Borough of Rumson

APPLICATION TO THE ZONING BOARD OF ADJUSTMENT

Denial Memorandum

Memorandum – Statement of Variances Review

DATE	11/20/25
DRAWN BY	JM
SHEET NO.	V-1

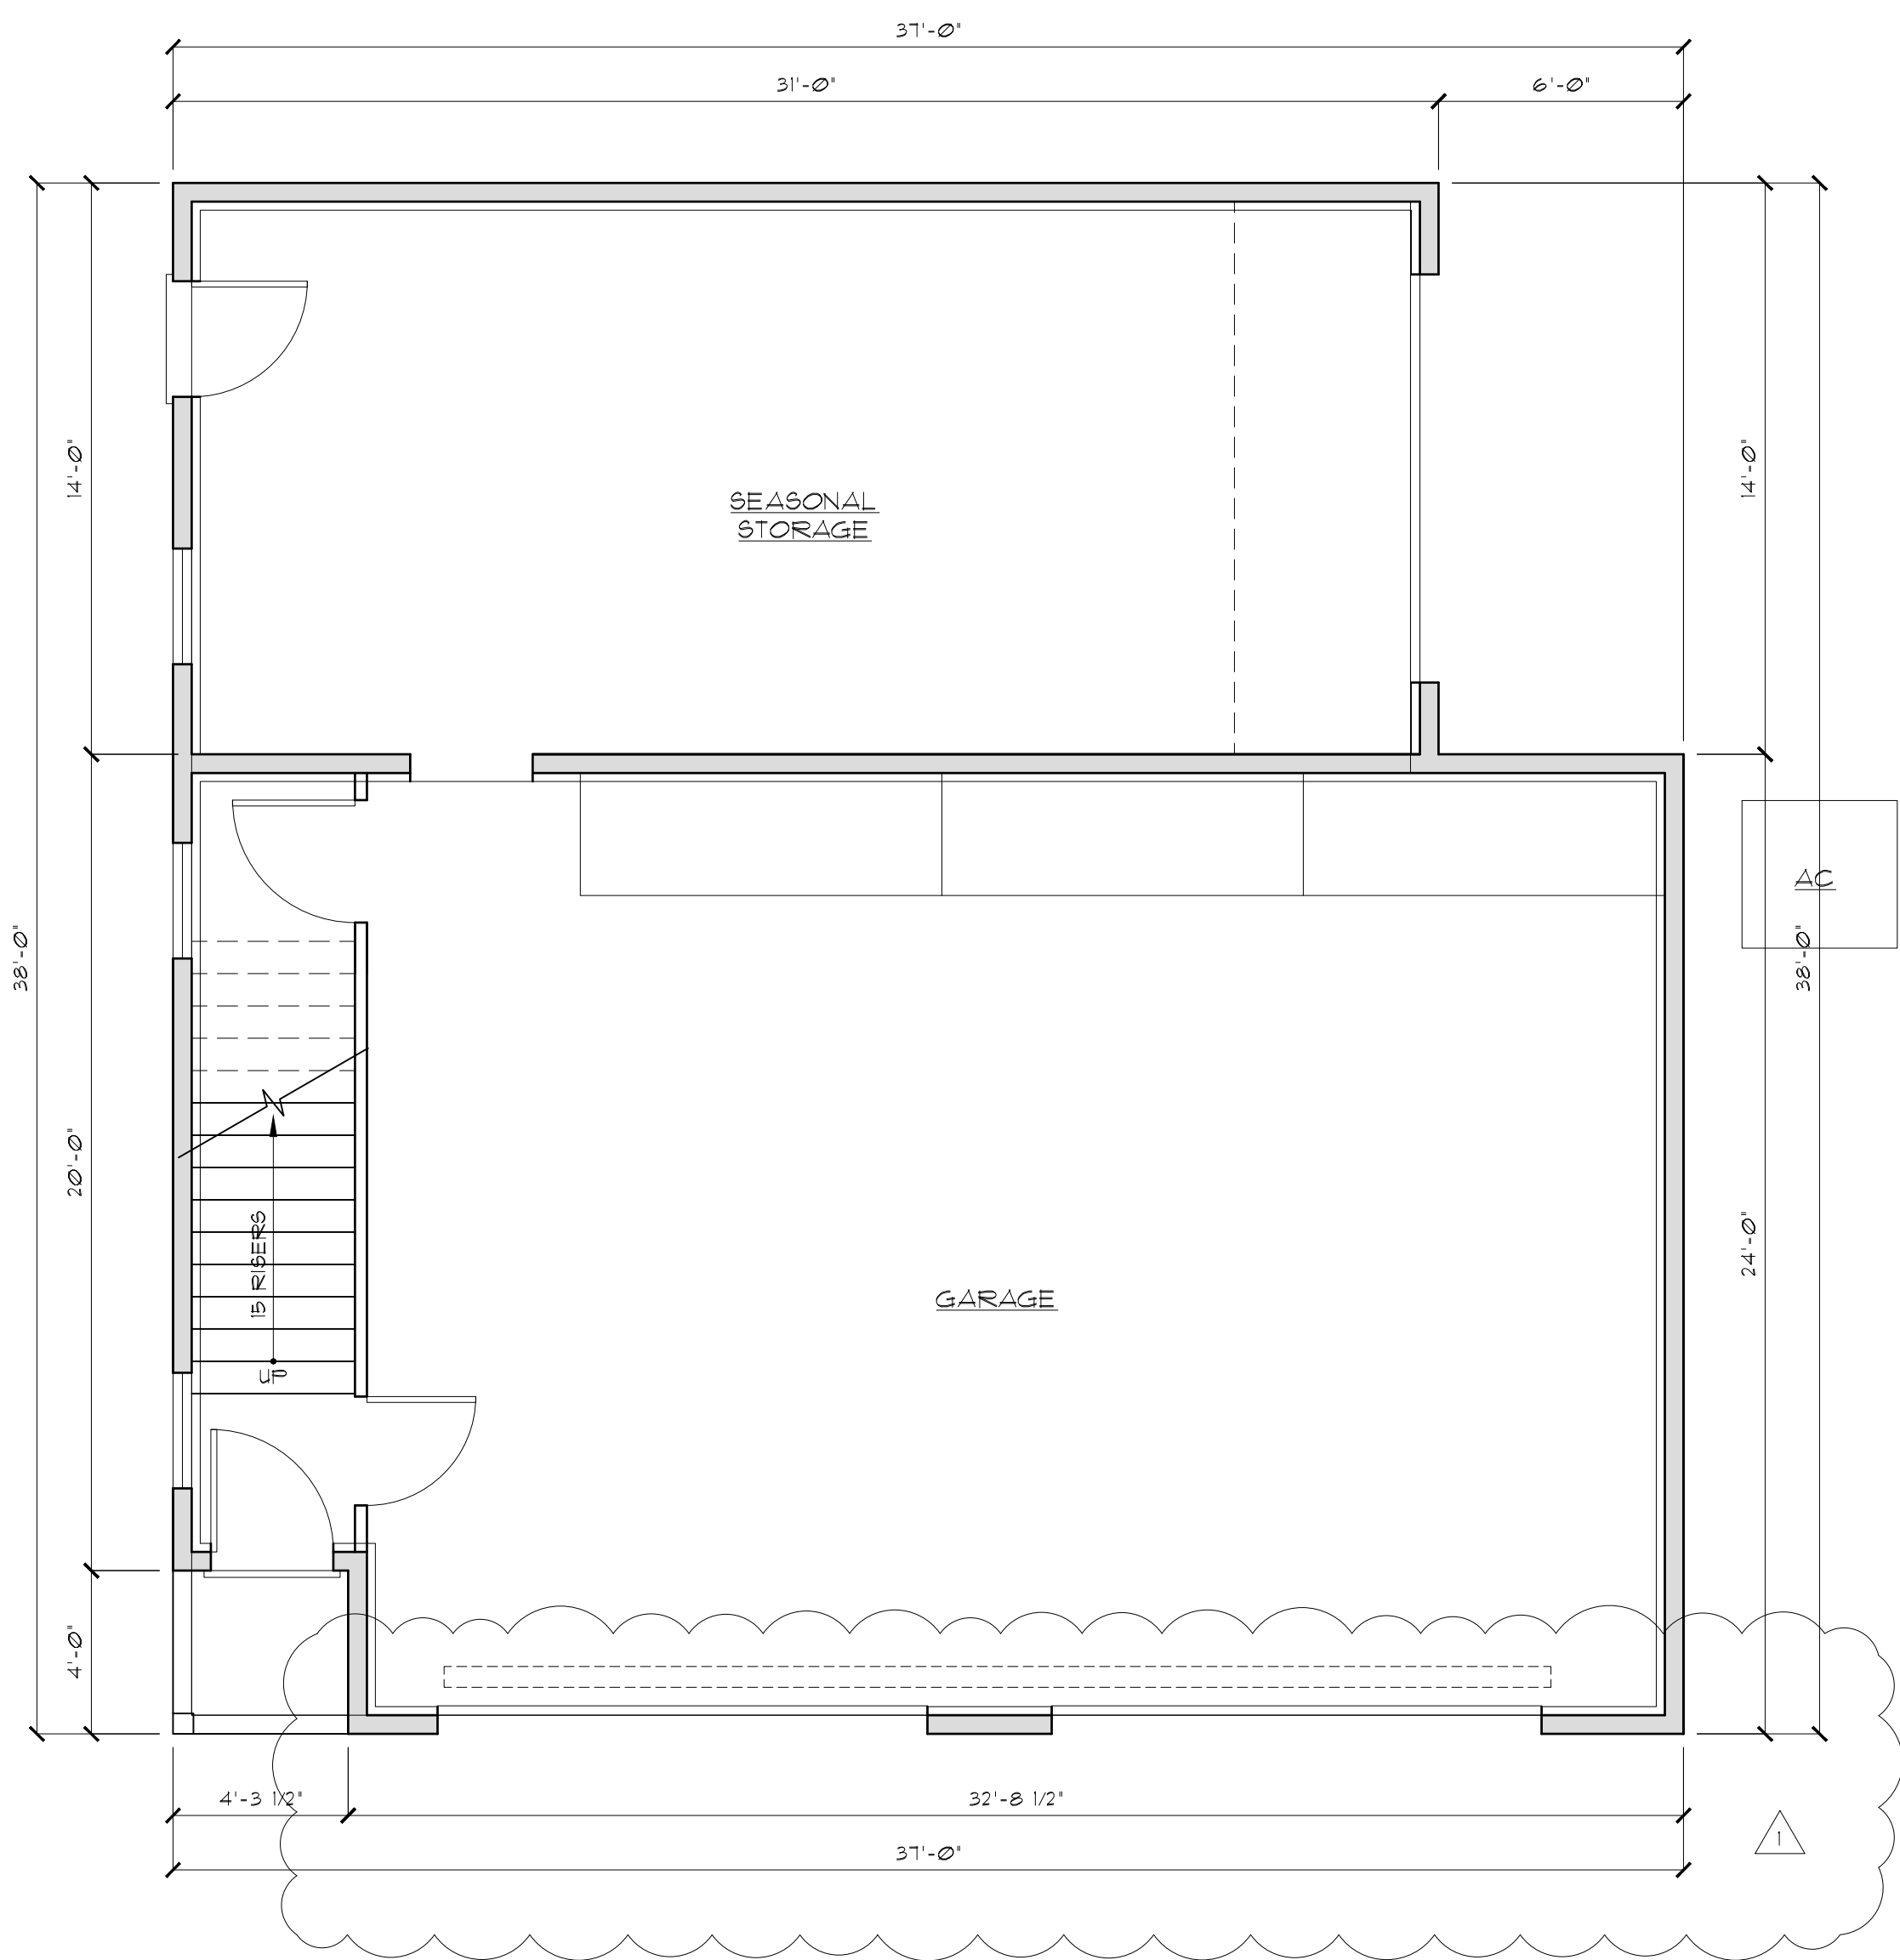
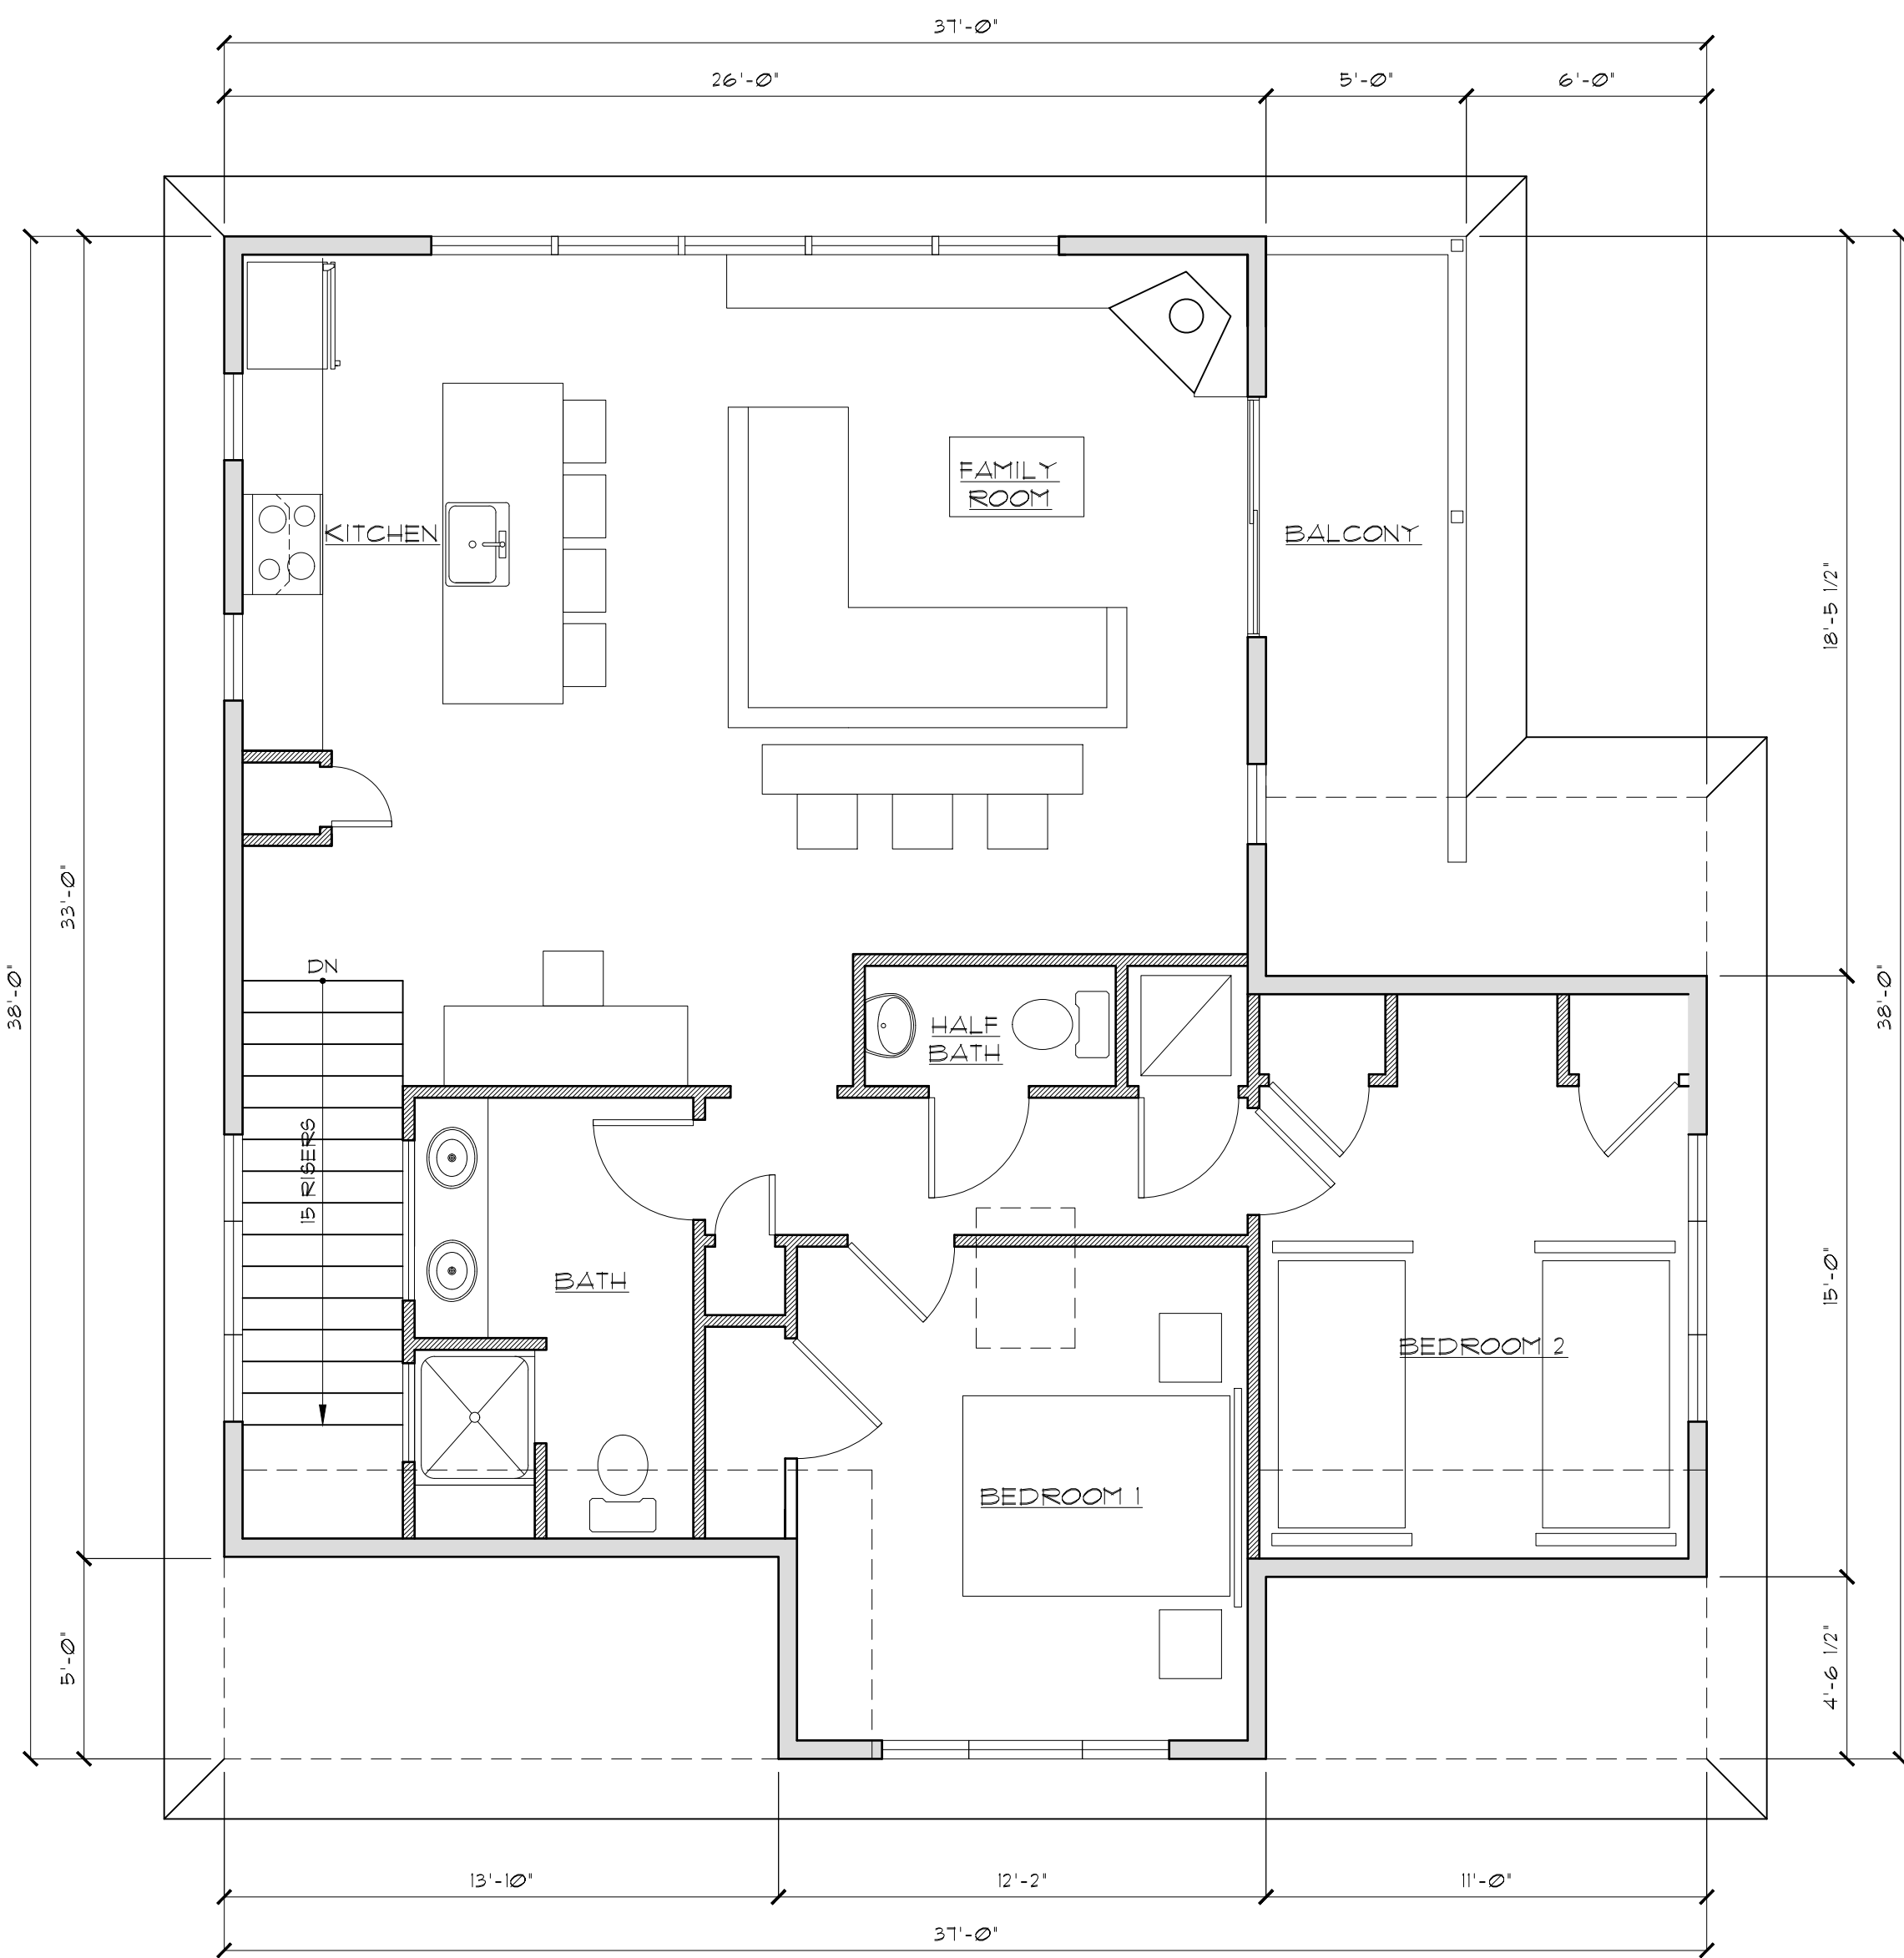
- (Sched 5-2) The proposed building height of 23.67' is measured from an elevated grading, approximately 3' higher than the original grade. The corrected building height is approximately 26.67, whereas accessory buildings may not exceed 24'.
- (Sched 5-4) Maximum Building and Lot Coverage exceeded.
- The proposed elevated grading plan requires approval from the Borough Engineer.
